## Architectural Review Board Staff Report

**Meeting Date:** August 12, 2021

**Location:** 18481 Outlet Blvd.

**Description:** **Chesterfield Blue Valley, Lot 1G SDSP:** A Site Development Section Plan, Landscape Plan, Lighting Plan, Architectural Elevations and Architectural Statement of Design for a 4.32-acre tract of land located along the east side of Outlet Boulevard, north of its intersection with Olive Street Road.

Figure 2: Site Relationships

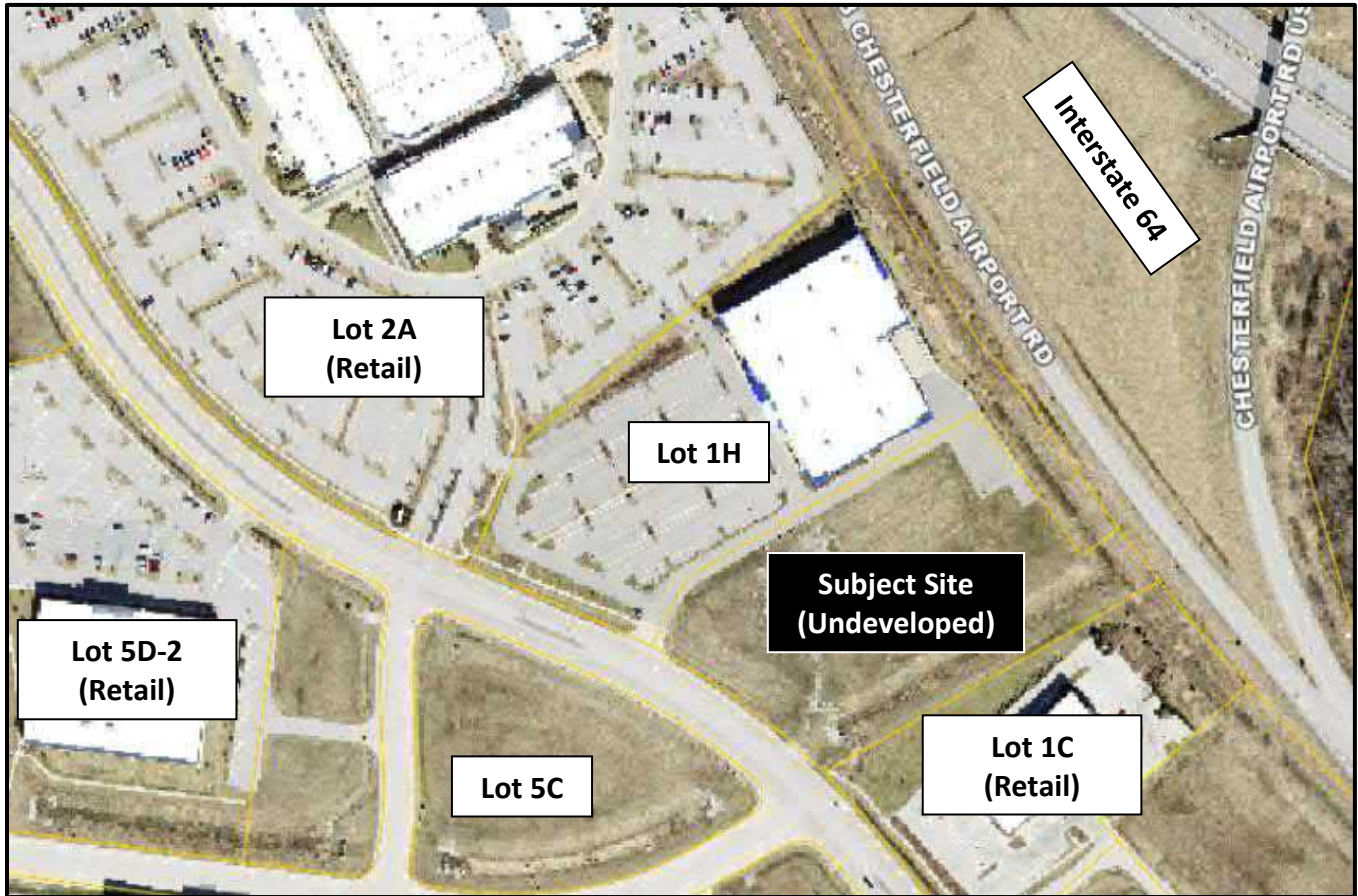
Lot 1G is located along the southeast boundary of Chesterfield Blue Valley development across the street from an undeveloped parcel to the southwest, a retail building to the southeast, and vacant building and parking lot on 1H to the northwest. Interstate 64 and a Stormwater Master Channel about the northeast side of the subject site. Lot 1G remains undeveloped to this day and will serve as an accessory parking area and carwash use for inventory vehicles for the automobile sales use of Lot 1H. However, as the parking area and carwash are both permitted uses located on Lot 1G, each of these uses could eventually become standalone uses, potentially separate from the user on Lot 1H.

Figure 3: Color Site Plan

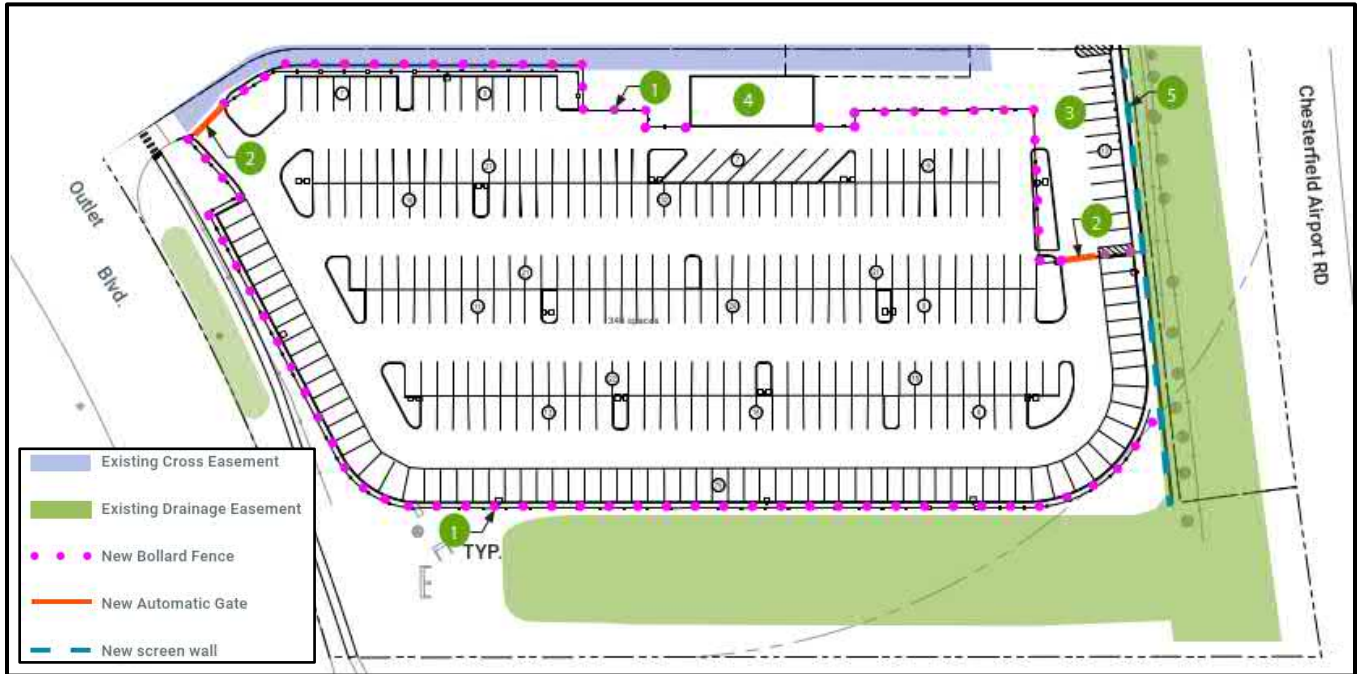
The subject site has vehicular cross access between both Lot 1G and Lot 1H. This proposal would fence off most of the proposed parking area on 1G for inventory vehicle parking, with a small carwash—incidental to inventory vehicle maintenance—located on the north side of the lot. Two (2) gates for vehicular access will be constructed: one located at the southwest corner of the site, and another located to the north. Bollard fencing will be utilized to enclose the inventory parking area with approximately 220 linear feet of it running across pavement to the south and north of the carwash. This bollard fencing is shown as pink hatching in Figure 3 below. A new pedestrian sidewalk will be constructed along Outlet Boulevard connecting to the existing sidewalks on both Lots 1C (southeast) and 1H (northwest).

Figure 6: Screening Wall Elevation (1G & 1H)

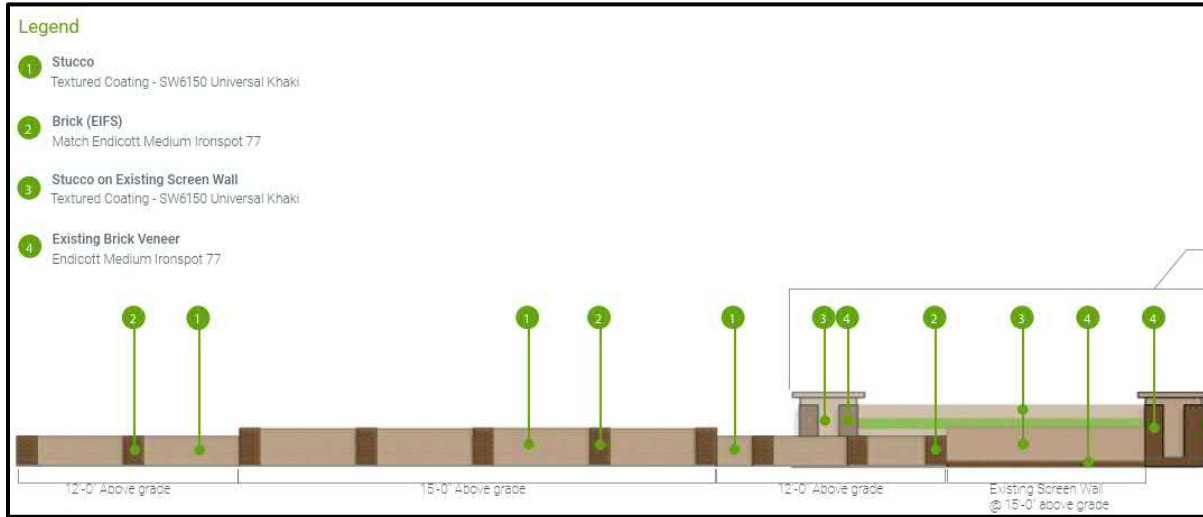
The parking area will feature a two-foot, six-inch (2'6") bollard fence surrounding a large portion of the site's parking area with gated access to this lot on the east and northwest sides. Notably, this bollard fencing will extend across 220 linear feet of pavement on both the north and south sides of the carwash. A detail of this bollard fencing is illustrated in Figure 4 below. A photo example of this bollard fencing is included in the ARB packet. The two (2) gates entering this inventory parking area will stand 6'0" at their highest point and will not be illuminated. A photo example of this gate and a detail are both found in the ARB packet as well.

The screening wall will be comprised of Concrete Masonry Units (CMU) with stucco finish and brick-style EIFS sections breaking up the design throughout. This brick-style EIFS will match the brick of the existing building on Lot 1H as well. The wall will be capped with sandstone coping.

Figure 7: Carwash Elevations

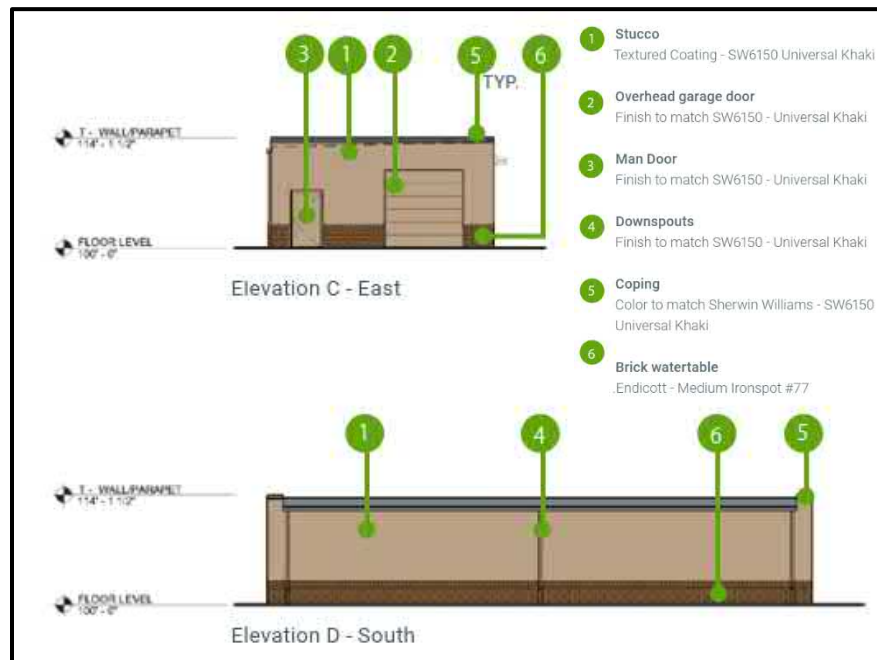
The carwash and screening wall will utilize a collection of materials that closely resemble those found on the existing building on Lot 1H. The carwash elevations feature a three-foot (3') high dark brick watertable design at the base of the structure, with textured tan EIFS comprising the remainder of each elevation before being capped with grey coping at the top of the structure. The overhead doors of the carwash will be metal painted to match the tan EIFS of the structure.
